Access Compliance Report Public Rights-of-Way (Curb Ramps)

Main Street: CHAPARRAL_CT Cross Street: STARLIGHT_RIDGE Location: SW

ADA ID: RPRK211018174758 Ramp Type: Type 4 - Parallel Initial Pass/Fail: Fail Overall Compliance: No Severity Score: 32

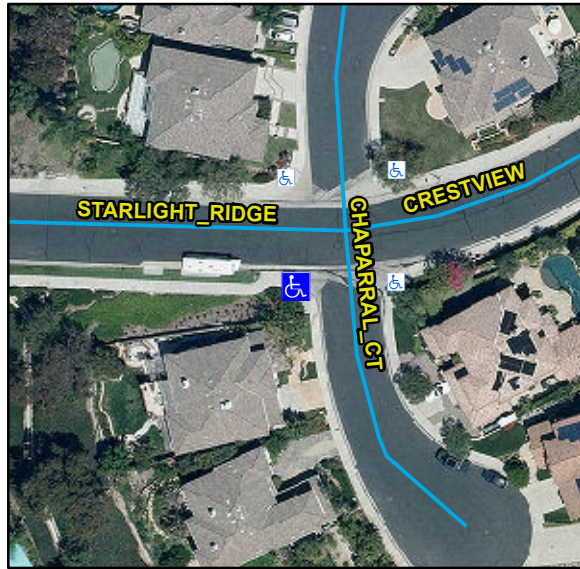
Compliance	Description	Data	Compliance	Description	Data
N/A	Ramp Length LT (in)	91	N/A	Ramp Length RT (in)	87
Yes	Ramp Width LT (in)	84	Yes	Ramp Width RT (in)	84
No	Ramp Run Slope LT (%)	19.3	Yes	Ramp Run Slope RT (%)	1.1
No	Ramp Cross Slope LT (%)	4.7	Yes	Ramp Cross Slope RT (%)	1.2
N/A	Landing Present	N/A	N/A	DWS Provided	N/A
N/A	Landing Length (in)	N/A	N/A	DWS Contrast	N/A
N/A	Landing Width (in)	N/A	N/A	DWS Length (in)	N/A
N/A	Landing Run Slope (%)	N/A	N/A	DWS Full Width	N/A
N/A	Landing Cross Slope (%)	N/A		DWS Offset Type	N/A
N/A	Landing Movement Obstructed?	N/A	N/A	DWS Offset Left (in)	N/A
	Landing Movement Type	N/A	N/A	DWS Offset Right (in)	N/A
N/A	Landing Shared	N/A			
N/A	Clear Space	Yes			
N/A	Clear Space To Crosswalk (in)	N/A			
N/A	Marked Crosswalk 1	No	N/A	Marked Crosswalk 2	No
	Crossing 1 Direction	E		Crossing 2 Direction	N
	Marked Crosswalk 1 Width (in)	N/A		Marked Crosswalk 2 Width (in)	N/A

Remove & Replace Curb Ramp With Two New Directional Ramps or Equivalent.

R304.3.2, R304.5.3, STD 1115
